# 4674 Kingston Road - Zoning Amendment Application – Appeal Report

Date: October 31, 2023 To: Scarborough Community Council From: Director, Community Planning, Scarborough District Ward: 25 - Scarborough-Rouge Park

Planning Application Number: 22 179753 ESC 25 OZ

## Attachment 4: Site Plan

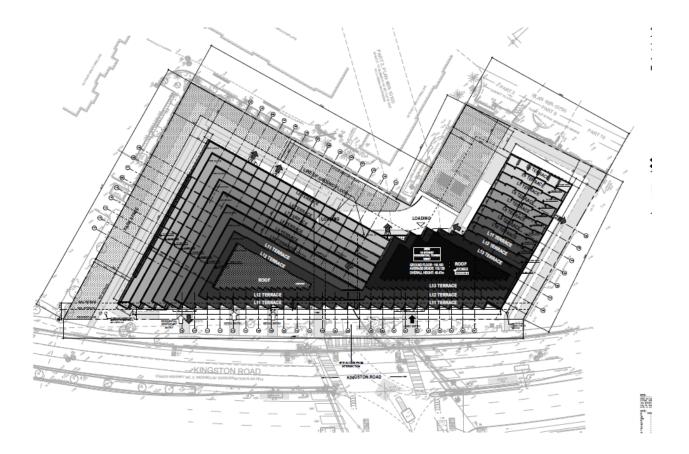
The proposed 13-storey building includes one level of underground parking (approximately 4 metres in depth, not including the concreate slab, below grade). The building and its parking garage are being proposed on an existing easement in favour of the City, as illustrated in Attachments 4 and 5. The existing easement accommodates a 2100 mm sanitary trunk sewer that traverses the site below grade. At this stage, Toronto Water and Engineering and Construction Services have advised that no encumbrances are permitted on top of the easement. Therefore, to address this position outlined in the commenting memo from Engineering and Construction Services, the Owner is required to provide a revised design for the new mixed-use building and associated servicing infrastructure that is outside of the easement to understand how it affects the development proposal.

In the event that the OLT allows the Zoning By-law Amendment appeal in whole or in part, this report recommends that the City Solicitor request the final Order should be withheld pending the confirmation of; water, sanitary, stormwater capacity, and review of on-site easements from the Chief Engineer and Executive Director, Engineering and Construction Services, or the determination of whether holding provisions are required in the Zoning By-law Amendment.
